# Access Compliance Report

## Public Rights-of-Way

| Intersection ID: 43360                  | Main Street: HIGHLAND_COMMONS_RD | Cross Street: RIDGEVIEW_COMMONS_DR      | Location: W            |
| ADA ID: 1B583379D338                    | Ramp Type: PerpDiag              | Initial Pass/Fail: Pass                 | Overall Compliance: No |

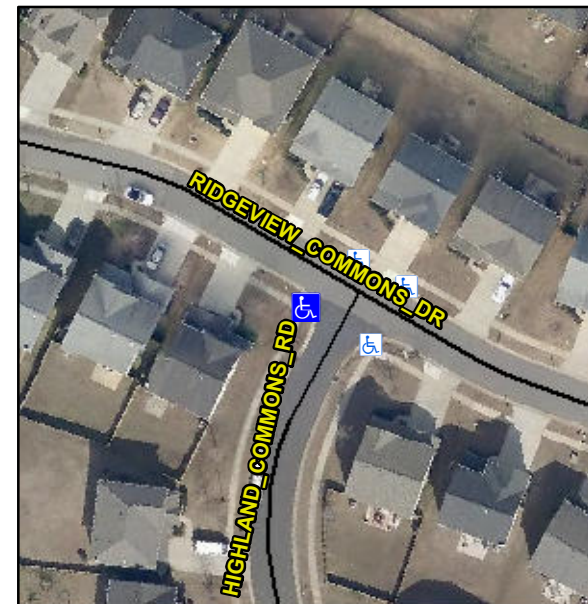
**Not Found, R304.5.3, R304.2.1, R305.2, R302.7.2**

| Compliance | Description           | Data   | Compliance | Description                 | Data  |
|------------|-----------------------|--------|------------|-----------------------------|-------|
| Yes        | Ramp Width (in)       | 48.0   | No         | Ramp XSlope (%)             | 3.2   |
| No         | Landing Width (in)    | 43.0   | Yes        | DWS Contrast?               | Yes   |
| No         | Landing X Slope (%)   | 4.3    | Yes        | DWS Full Width?             | Yes   |
| No         | Gutter Lip Ht (in)    | 1.0    | No         | Gutter X Slope (%)          | 3.5   |

**Remove & Replace Curb Ramp With Two New Directional Ramps or Equivalent. Remove & Replace Gutter.**
